## **Tehama-Colusa Canal Authority (TCCA) – Fish Passage Improvement Project at Red Bluff Diversion Dam**

### **Pumping Plant and Fish Screen Project Hydraulics: Red Bluff Pumping Plant Fish Screen Hydraulic Model Study (1:42 Scale)**

**PEER REVIEW DOCUMENTATION**  
**Hydraulic Investigations and Laboratory Services Group, 86-68460**

<b>Client/Project: TCCA Fish Passage Improvement Project</b>							
Reference Page or Sheet No.		Reviewer	Review Comment	Comment Type	Responder	Response	Follow-up Item No.
		<b>Project No.: 380710.FD.PM.RV</b>		<b>F</b>	Fatal flaw - must be revised		
		<b>Phase: July 29, 2009 Physical Hydraulic Model TM</b>		<b>S</b>	Serious problem, needs to be addressed, could escalate to 'F'		
		<b>Date: September 2, 2009</b>		<b>C</b>	Coordination problem - resolve		
		<b>Notes: Return QC comments to Joe Green-Heffern/SAC and the applicable Project Technology Lead Engineer by email</b>		<b>N</b>	Note to originator, change not necessary, could result in better future work product		
Reference Page or Sheet No.		Reviewer	Review Comment	Comment Type	Responder	Response	Follow-up Item No.
General	Gatton	This is a very well written draft that clearly summarizes many mo

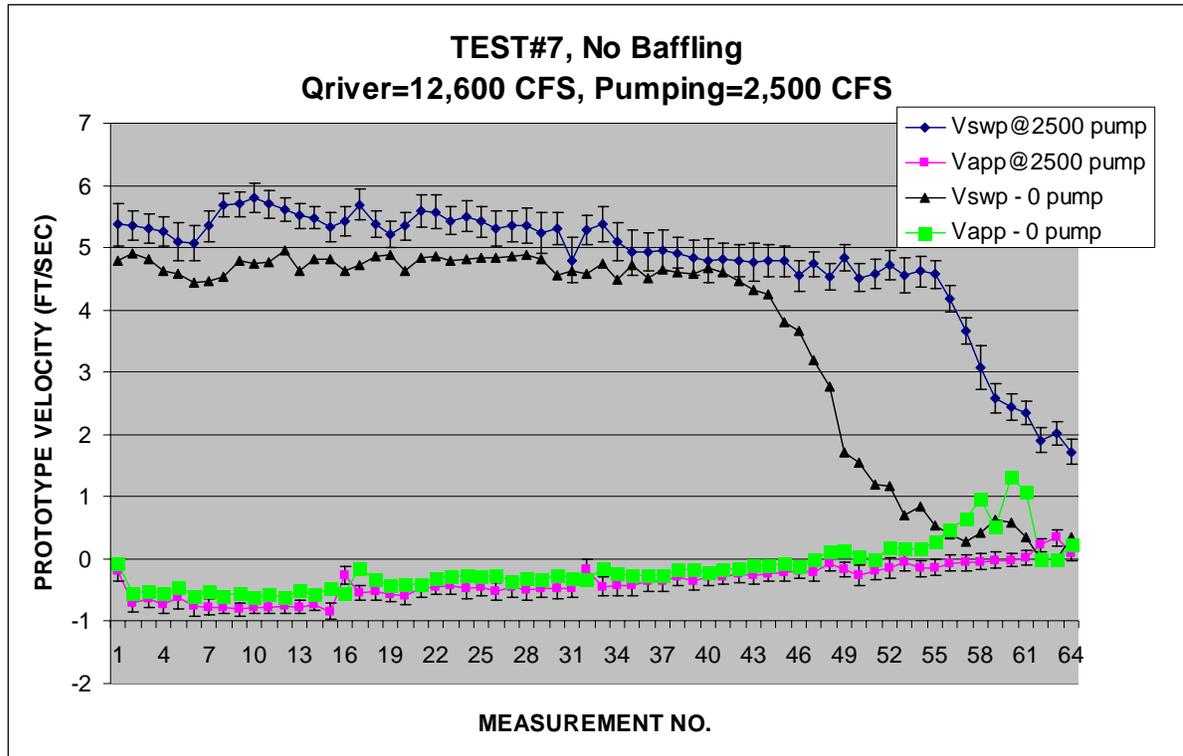
Page 6	Gatton	First paragraph add a sentence of two explaining that the final design has for cost reasons moved 100 feet upstream but it is TSC's opinion that this does not affect the results of the model.	S	TVermeiden	Change completed 8/17/2009		
Page 12	Gatton	Figure 9 point out that + is downstream and away from the screen. The negative approach velocities are a bit confusing. Also from a terminology point of view we refer to them as "blowout bays" not "3 bypass panels".	C	TVermeiden	Added two sentences on pages 9 and 11 describing the 2-D velocity vector orientation. Change completed 8/17/2009		
Page 12	Gatton	On the paragraph "Fish Screen Baffling" I have the same comment as on page 5 above.	F	TVermeiden	See page 5 response.		
Page 13	Gatton	Figure 10 has the same comments as Figure 9.	C	TVermeiden	Added two sentences on pages 9 and 11 describing the velocity vector orientation. Change completed 8/17/2009
